# Carolina Sandhills National Wildlife Refuge

## Road Safety Audit

# **Road Safety Audit Report**

US Route 1 and Wildlife Refuge Entrance

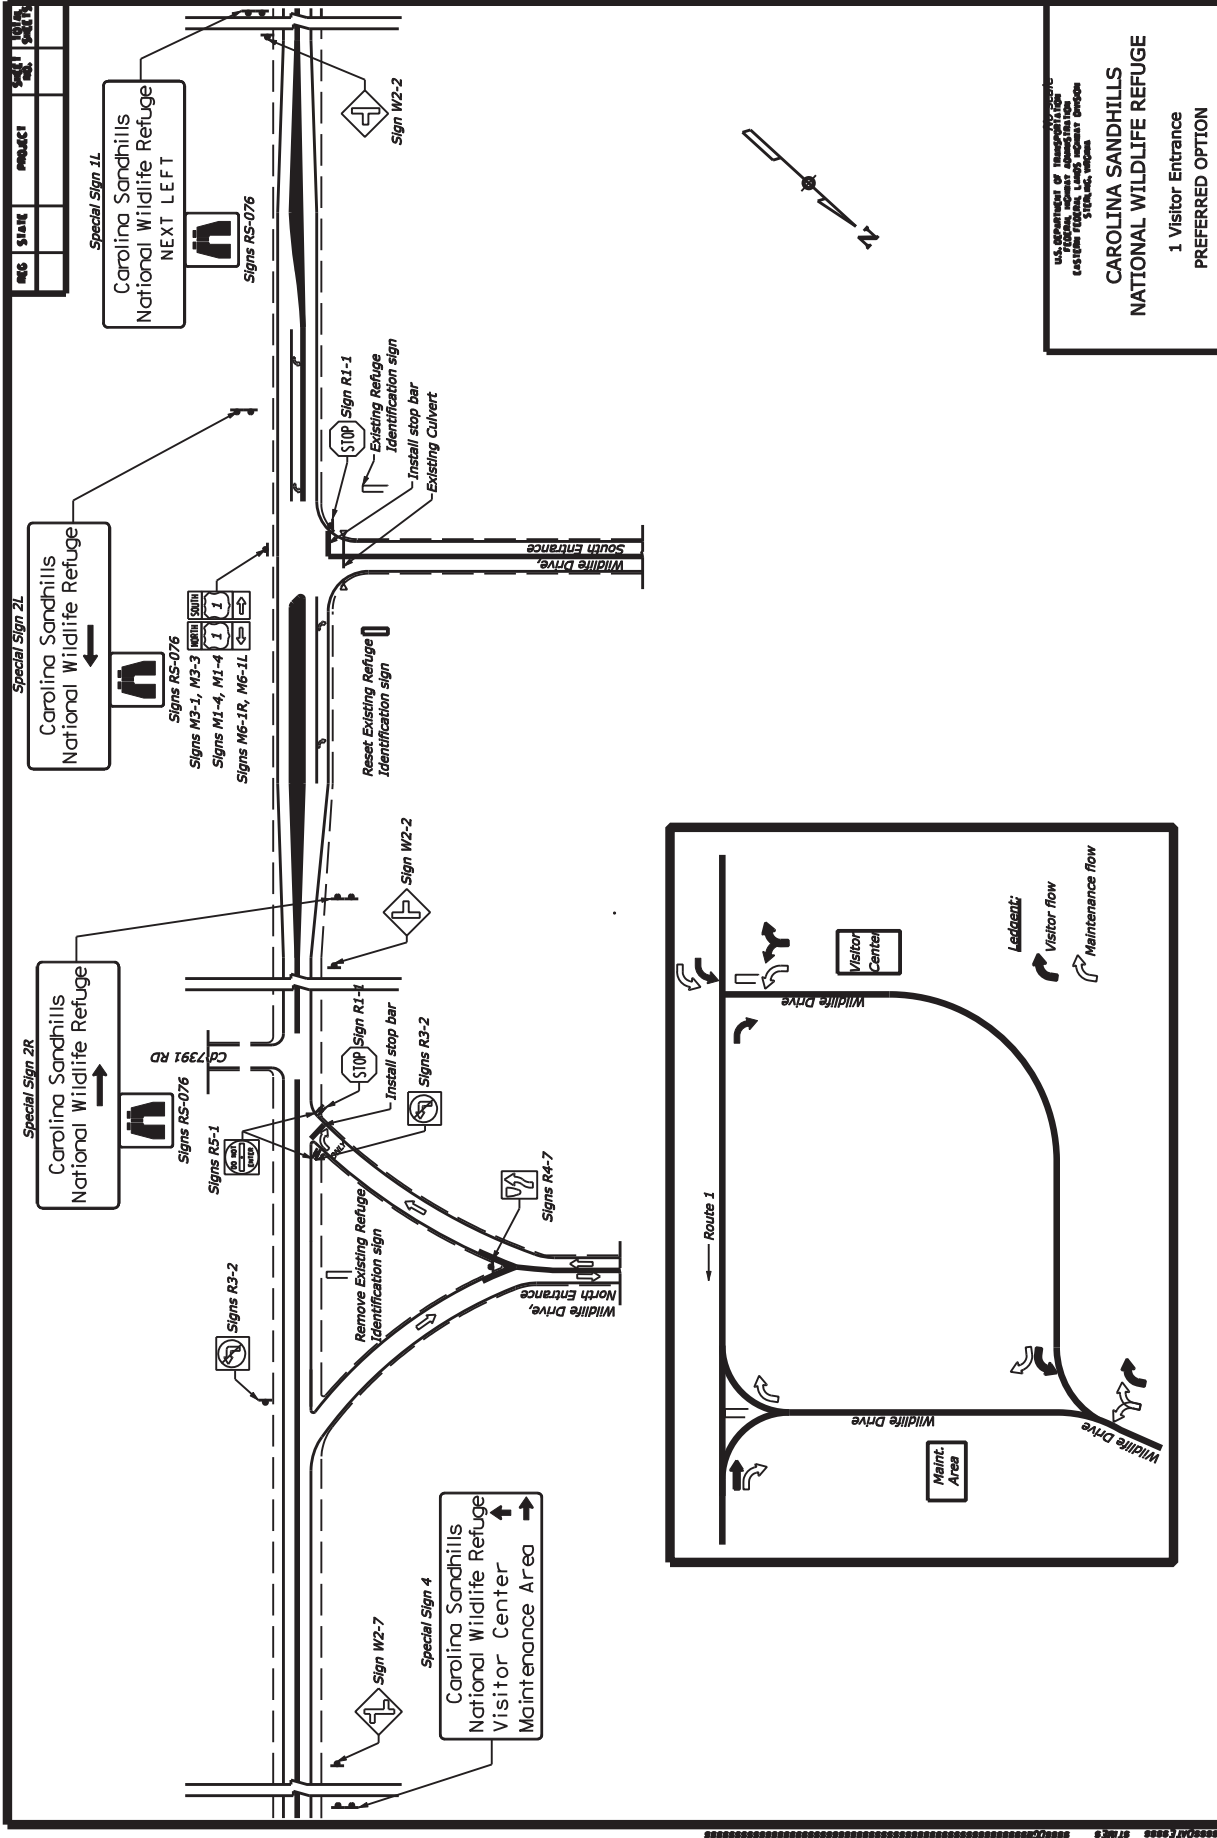
- Install advance guide signs “Carolina Sandhills National Wildlife Refuge Next Right / Left” as shown on diagram.
- Replace and redesign the “Carolina Sandhills National Wildlife Refuge” sign and the “Refuge Office (right arrow), Visitor Info (right arrow)” sign as shown on diagram.

- Add right turn lanes along US Rte 1 southbound approaching both Wildlife Drive intersections, and a left turn lane for northbound US Rte 1 traffic approaching the south Wildlife Drive entrance. Any proposed lane widening will require coordination and concurrence from SCDOT.

- Install Keep Right (R4-7) sign, No Left Turn (R3-2) in both directions and Do Not Enter (R5-1) signs as shown on diagram.
- Place Side Road (W2-2) sign in advance of the south entrance in the northbound direction, and the Offset Side Road (W2-7) sign in advance of the north entrance in the southbound direction as shown on diagram.

- Restrict passing at the intersection of both Entrances according to MUTCD guidelines as shown on diagram.
- Upgrade stop signs at both entrances and stop bars according to MUTCD guidelines as shown on diagram.

- Install guide sign assembly to show “US Route 1 North / Left and South / Right” as shown on diagram for exiting Refuge traffic at the south Wildlife Drive intersection.

**CAROLINA SANDHILLS  
NATIONAL WILDLIFE REFUGE**  
Maintain 2 Visitor Center Entrances  
With Minor Realignment  
ALTERNATE 2

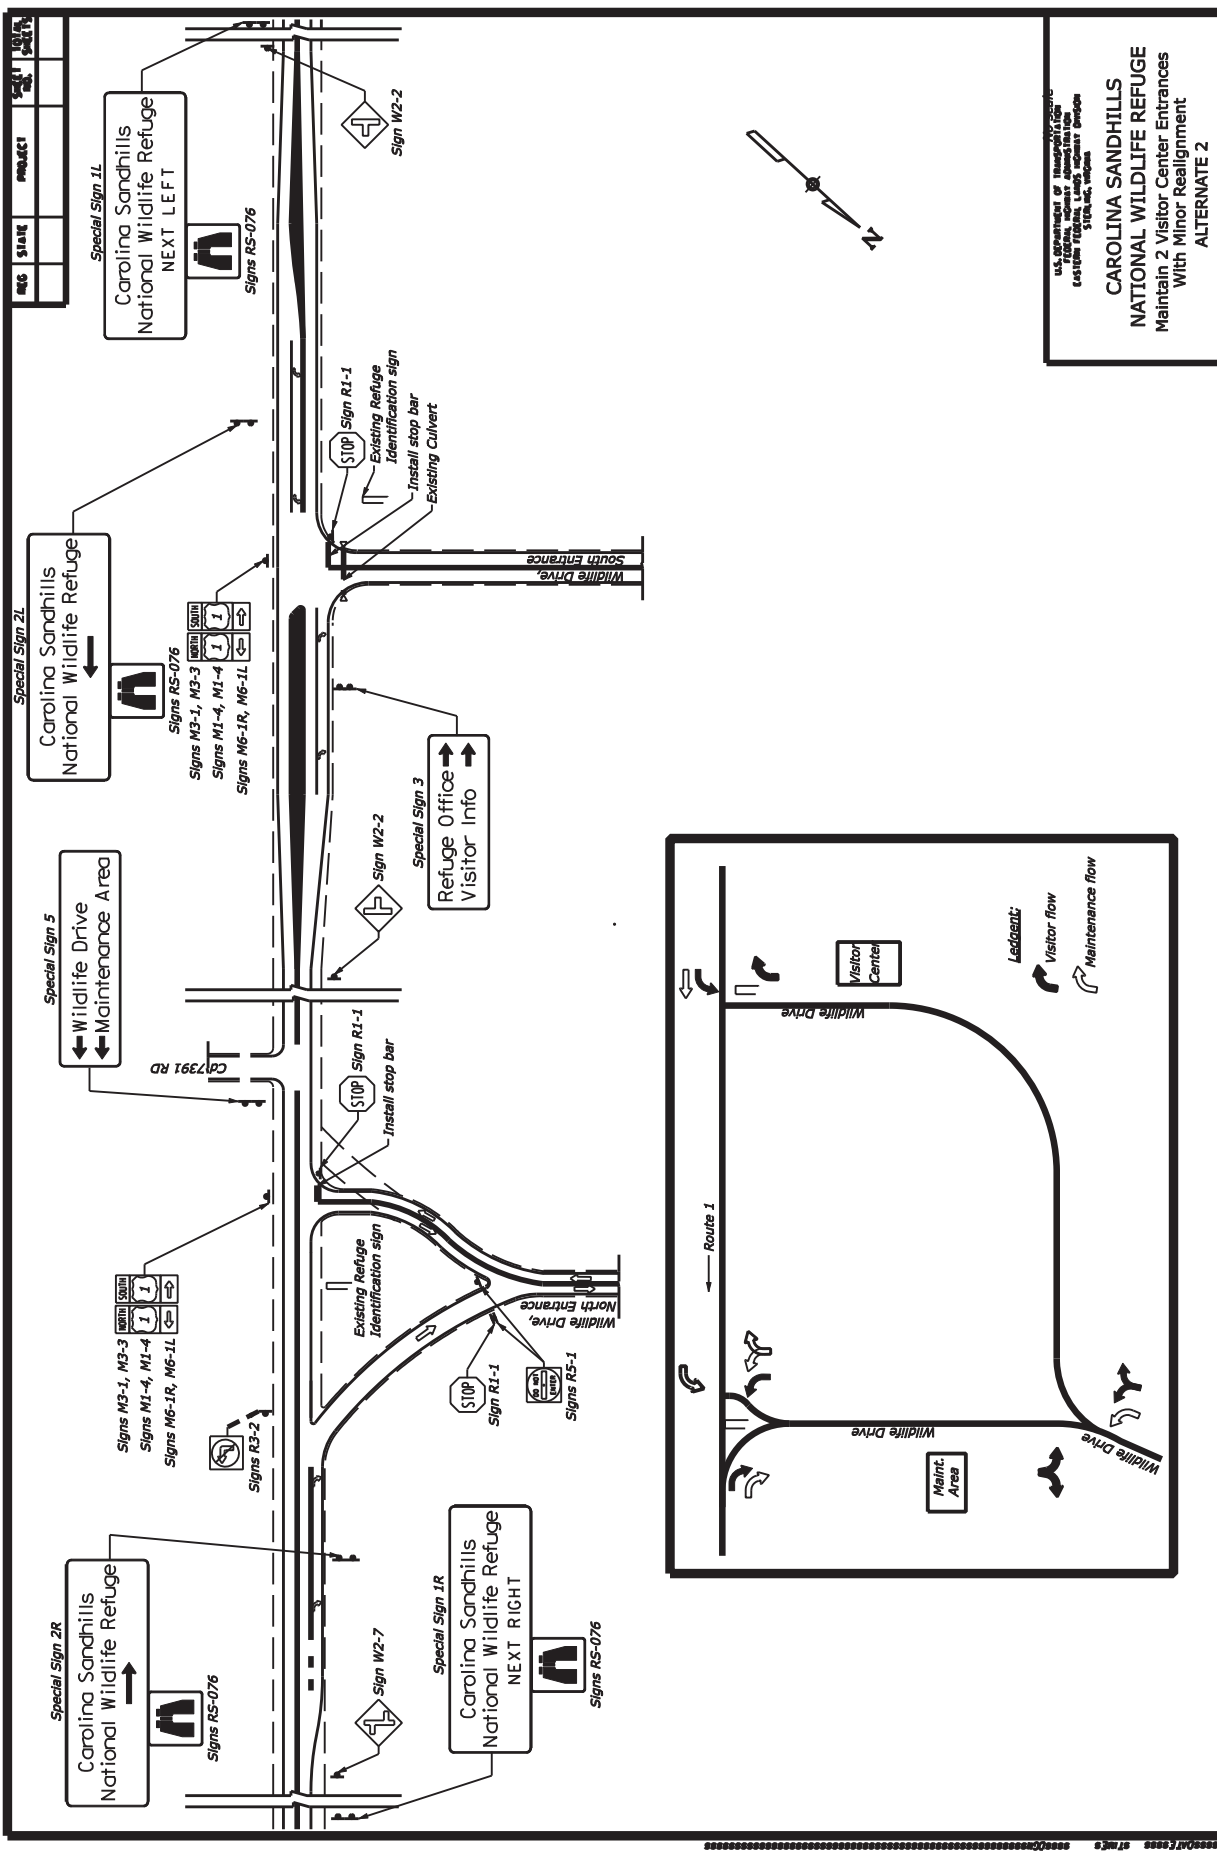
- Install advance guide signs “Carolina Sandhills National Wildlife Refuge Next Right / Next Left” as shown on diagram.
- Replace and redesign the “Carolina Sandhills National Wildlife Refuge” sign, “(left arrow) Wildlife Drive, (left arrow) Maintenance Area” sign, and the “Refuge Office (right arrow), Visitor Info (right arrow)” sign as shown on diagram.

- Add right turn lanes approaching both US Rte 1 southbound Wildlife Drive intersections, and a left turn lane for northbound US Rte 1 traffic approaching the south Wildlife Drive entrance. Any proposed lane widening will require coordination and concurrence from SCDOT.

- In realigning the north Wildlife Drive Y-intersection, install new Stop bar, Stop (R1-1), Do Not Enter (R5-1), and No Left Turn (R3-2) signs as shown in the diagram to allow entrance at both legs of the Y-intersection.

- Place Side Road (W2-2) sign in advance of south entrance in the northbound direction and the Offset Side Road (W2-7) sign in advance of the north entrance in the southbound direction as shown on diagram.

- Restrict passing at the intersection of both Entrances according to MUTCD guidelines as shown on diagram.
- Upgrade stop signs at both entrances and stop bars according to MUTCD guidelines as shown on diagram.

- Install guide sign assembly “US Rte 1 North / Left and South / Right” as shown on diagram for exiting Refuge traffic at both south and north Wildlife Drive intersections.
